Subject:	Town of Cumberland Town Office Parking Expansion -Major Site Plan Review
From:	Carla Nixon, Town Planner
To:	Town of Cumberland Planning Board
Date:	April 16, 2020

Subject:Town Office Parking ExpansionTown of Cumberland Site Plan Review ApplicationResponse to Peer Review Comments dated 4/13/2020

C-302

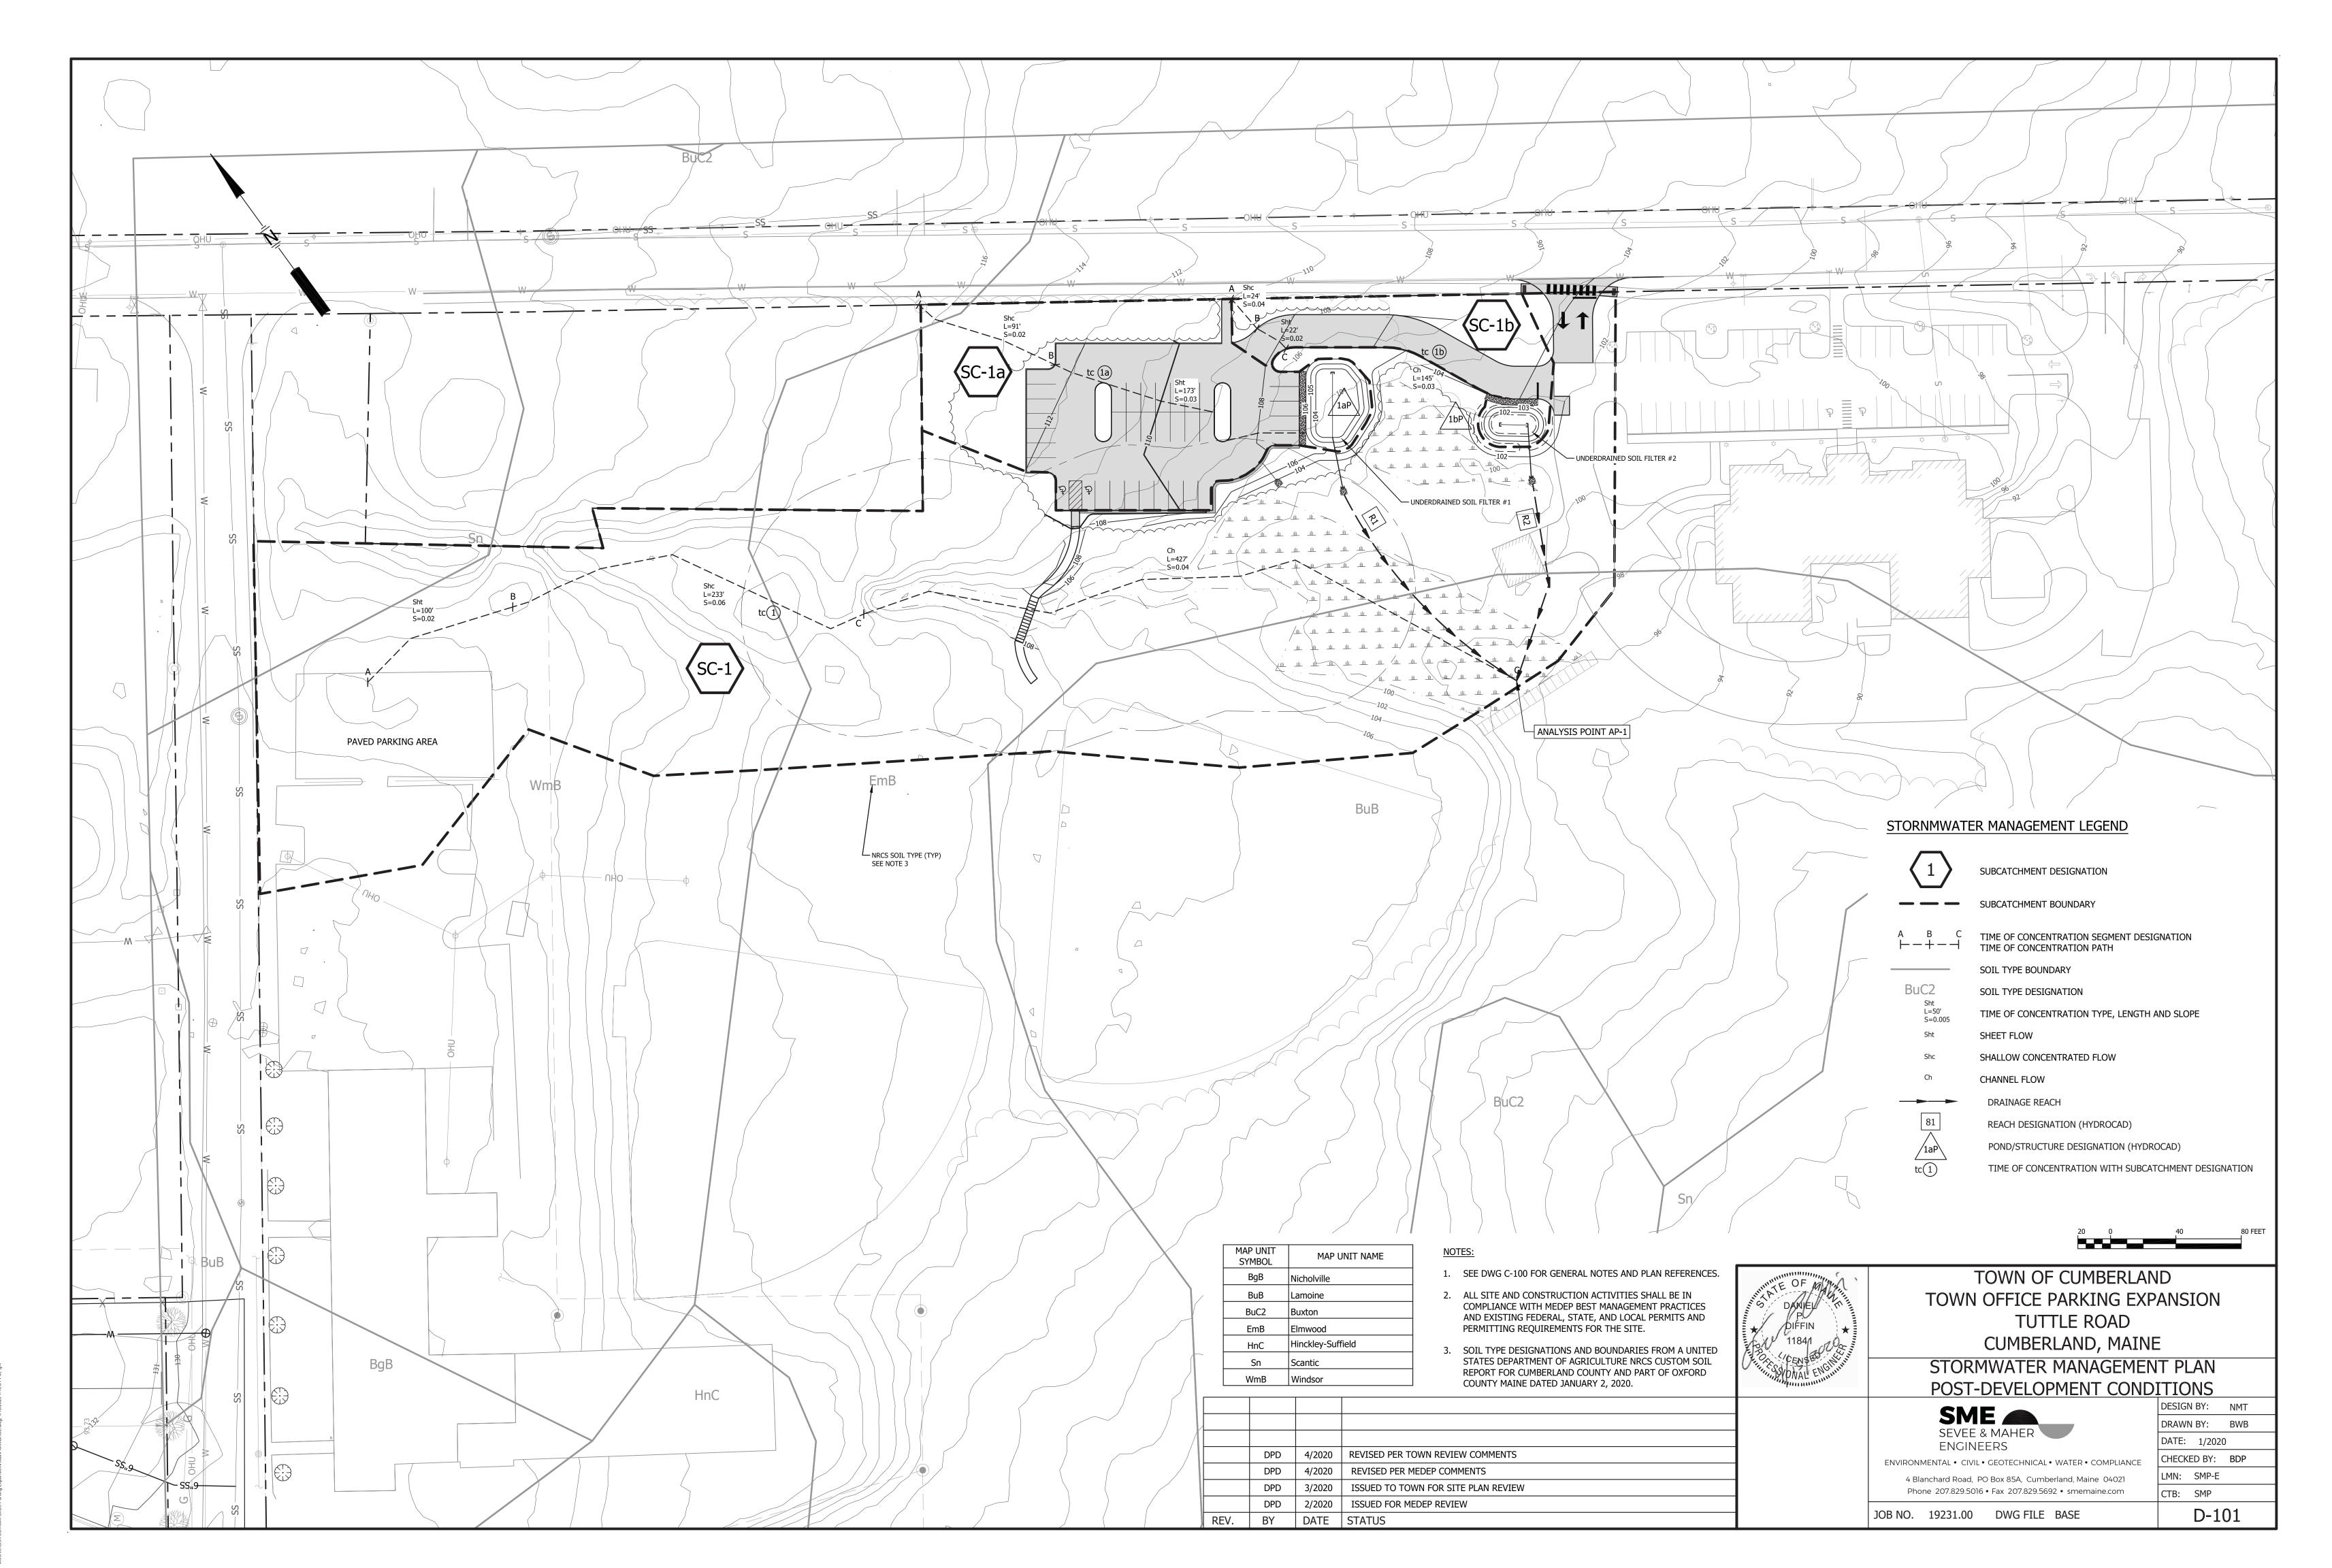
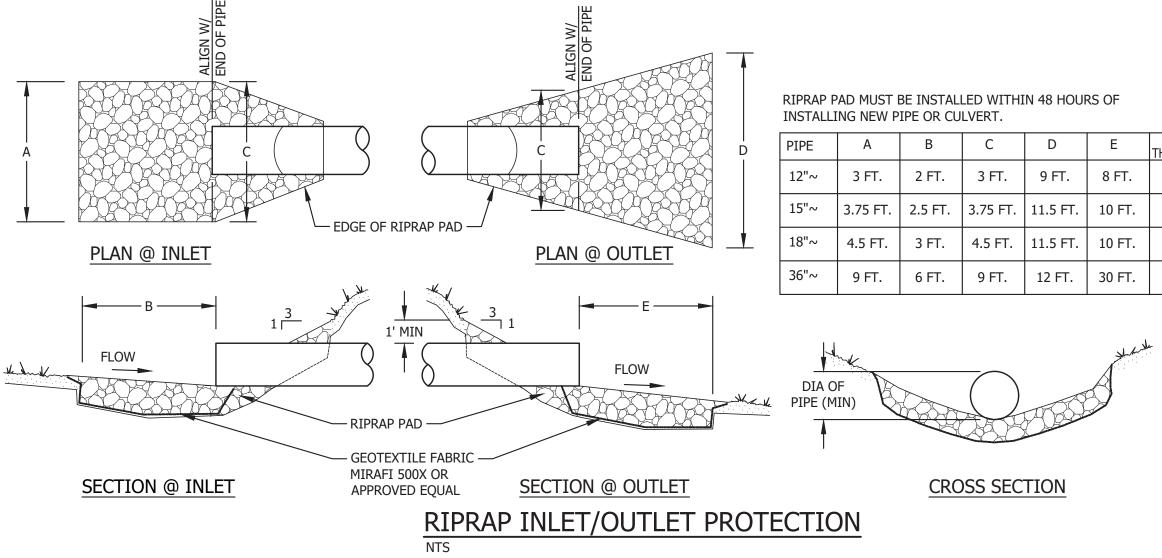
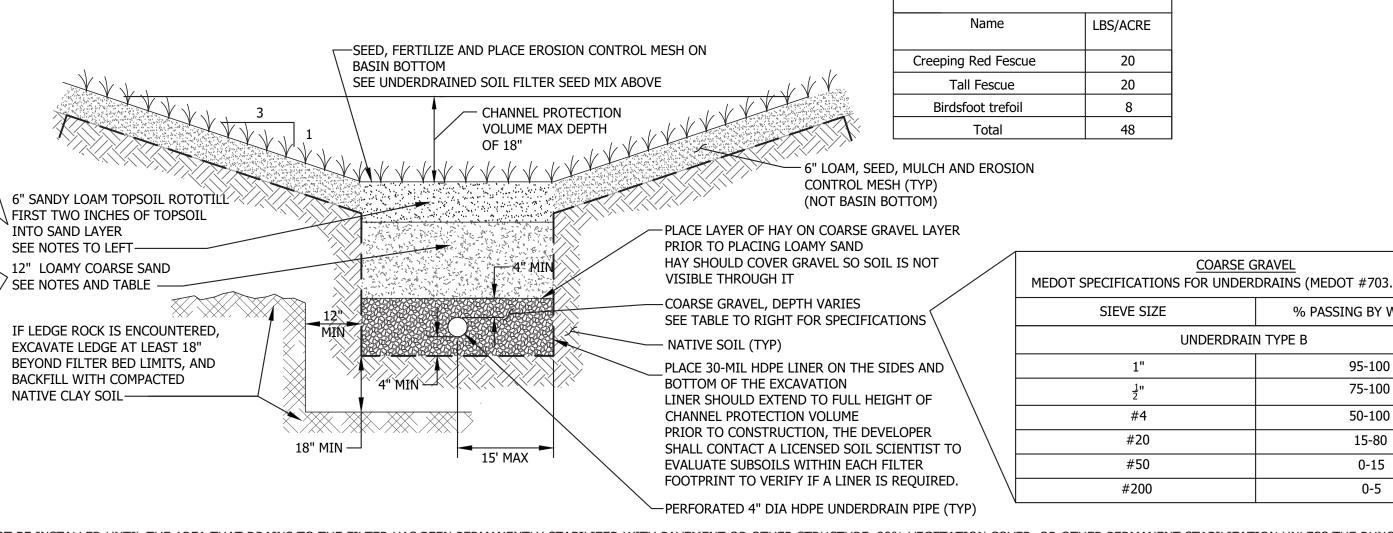
- A hydrometer test to determine the clay component of the soil should be included on plan sheet C302 under Testing and Submittals
 - Provide test pit information witnessed by a Soil Scientist for the UDSF

Show typical berm section on plans

<u>SME Response</u>: The contractor will be required to run the hydrometer test to confirm that the clay content of the Coarse Sand Layer is less than 2%. A note was added to the detail as requested.

<u>SME Response</u>: A typical berm section has been added on Drawing C-302.
